Our ref: CEO-24-1357

Re: HS2 Road Safety Audits

Phase 2A Enabling Civils Works (ECW2) M6 Slips and Yarnfield Lane, Site 1 – Road Safety Audit Stage 1 Designers Response Report

Appendix B. Problem location plan

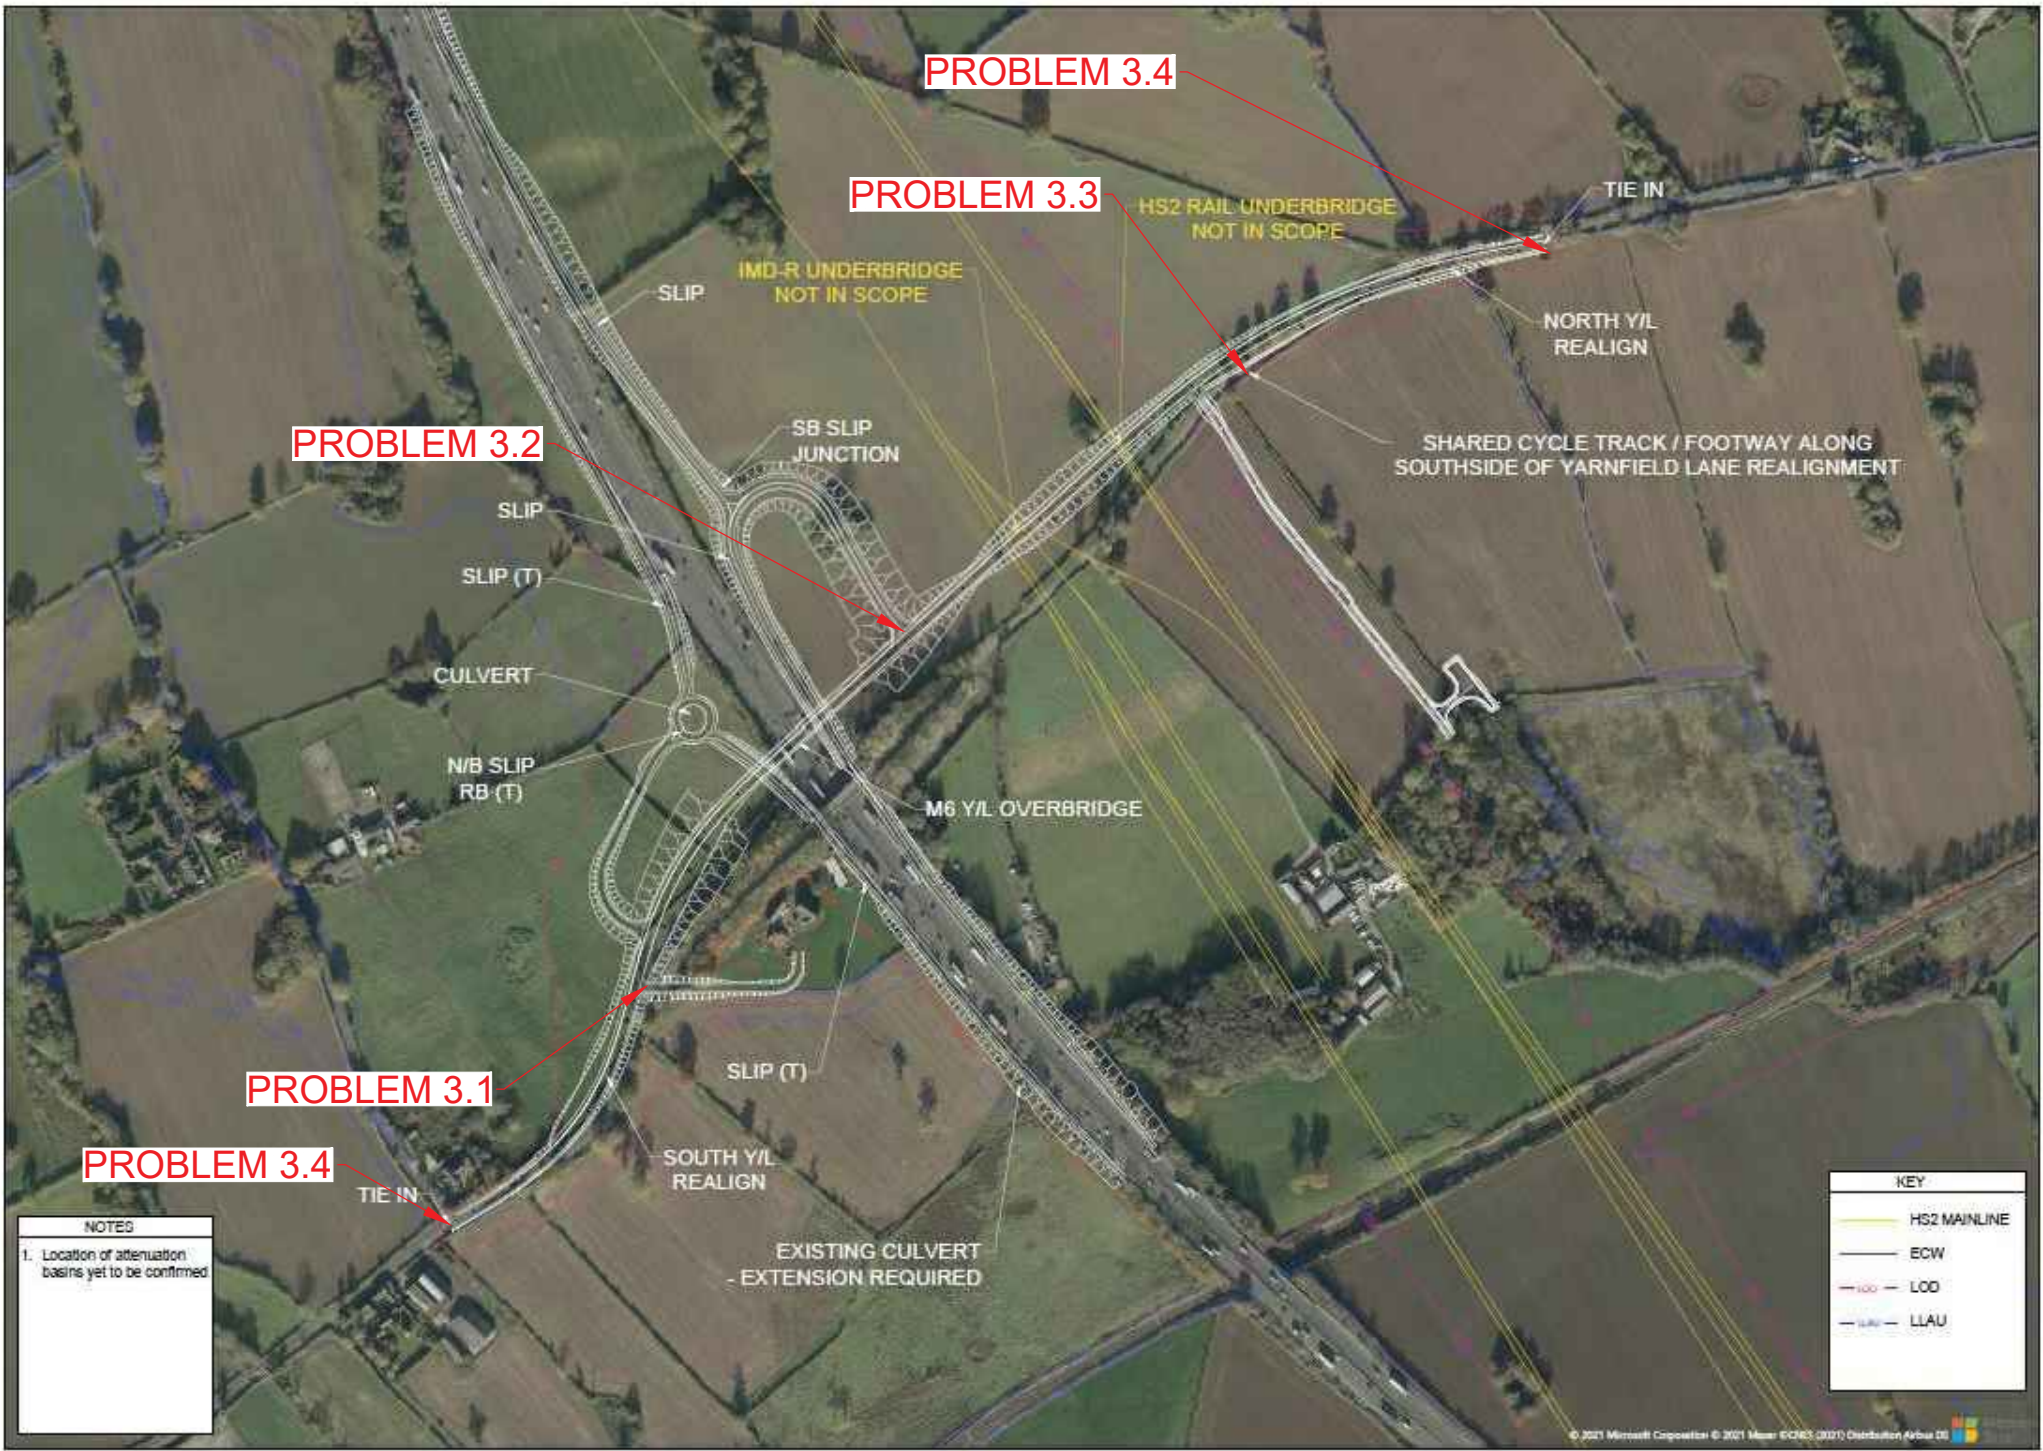
Location:	Junction of farm access and Yarnfield Lane (drawing ref: 2EW02-KIC-HW-DPP-WS05-000001)
Summary:	Risk of junction collisions could lead to motorists being injured.
	The scheme proposes to provide a new farm access on Yarnfield Lane at chainage 250m. Visibility from the new access to the right could be restricted should a vehicle restraint system, bridge parapet, fence or other street furniture be placed within the visibility splay. Any restriction to visibility will increase the risk of collisions between turning vehicles and oncoming traffic and could lead to motorists being injured.
Recommendation:	It is recommended that sufficient visibility for predicted traffic flows and 85 th percentile speeds on Yarnfield Lane is provided from the farm access.

Location:	M6 southbound access junction with Yarnfield Lane (drawing ref: 2EW02-KIC-HW-DPP-WS05-000001)
Summary:	Risk of junction collisions could lead to motorists being injured.
	The scheme proposes to provide a new junction from the M6 southbound access on Yarnfield Lane at chainage 600m. Visibility from the new junction to the right could be restricted should a vehicle restraint system, bridge parapet, fence or other street furniture be placed within the visibility splay. Any restriction to visibility will increase the risk of collisions between turning vehicles and oncoming traffic and could lead to motorists being injured.
Recommendation:	It is recommended that sufficient visibility for predicted traffic flows and 85 th percentile speeds on Yarnfield Lane is provided from the junction.

Location:	Yarnfield Lane footway / cycleway at chainages 0m and 1203m (drawing refs: 2EW02-KIC-HW-DPL-WS05-000059 and 000160)
Summary:	Risk of pedestrians and cyclists being struck by vehicles, leading to them being injured.
	The scheme proposes a new footway / cycleway along the southern verge of Yarnfield Lane. The terminal points of the facility are at chainages 0m and 1203m. There are no details of how pedestrians and cyclists are to join or leave the facility, or what the facility links to. Therefore, as they join or leave the facility, pedestrians and cyclists could be in conflict with vehicles, leading to collisions and associated injuries.
Recommendation:	It is recommended that suitable terminal points are provided on the footway / cycleway to allow pedestrians and cyclists to join and leave the facility.

No.	RSA Problem	RSA Recommendation	Design Organisation Response	Overseeing Organisation Response	Agreed RSA Action
3.1	Risk of junction collisions could lead to motorists being injured. The scheme proposes to provide a new farm access on Yarnfield Lane at chainage 250m. Visibility from the new access to the right could be restricted should a vehicle restraint system, bridge parapet, fence or other street furniture be placed within the visibility splay. Any restriction to visibility will	It is recommended that sufficient visibility for predicted traffic flows and 85th percentile speeds on Yarnfield Lane is provided from the farm access.	Accept Full junction visibility is achieved, and is measured in accordance with CD 123 where the X distance is 2.4m on the minor road and the Y distance along the major road is 160m (des. min SSD for 85kph design speed Yarnfield Lane) in both directions.	Agreed Discussed at meeting 03/09/22

3.2	Risk of junction collisions could lead to motorists being injured. The scheme proposes to provide a new junction from the M6 southbound access on Yarnfield Lane at chainage 600m. Visibility from the new junction to the right could be restricted should a vehicle restraint system, bridge parapet, fence or other	It is recommended that sufficient visibility for predicted traffic flows and 85th percentile speeds on Yarnfield Lane is provided from the junction.	Accept Junction visibility to the left is achieved, and is measured in accordance with CD 123 where the X distance is 2.4m on the minor road and the Y distance along the major road is 160m (des. min SSD for 85kph design speed Yarnfield Lane) in both directions. A departure from standard is proposed for reduced visibility to the right due to the crest of the M6 overbridge.	Agreed Discussed at meeting 03/09/22

No.	RSA Problem	RSA Recommendation	Design Organisation Response	Overseeing Organisation Response	Agreed RSA Action
	street furniture be placed within the visibility splay. Any restriction to visibility will increase the risk of collisions between turning vehicles and oncoming traffic and could lead to motorists being injured.		Mitigation measures will be provided with advance warning signs to motorists on Yarnfield lane included to advise of junction ahead.

3.4	Risk of pedestrians and cyclists being struck by vehicles, leading to them being injured. The scheme proposes a new footway / cycleway along the southern verge of Yarnfield Lane. The terminal points of the facility are at chainages 0m and 1203m. There are no details of how pedestrians	It is recommended that suitable terminal points are provided on the footway / cycleway to allow pedestrians and cyclists to join and leave the facility.	Agreed – the alignment design will be updated to provide suitable termination points in line with best practice.	Agreed Discussed at meeting 03/09/22
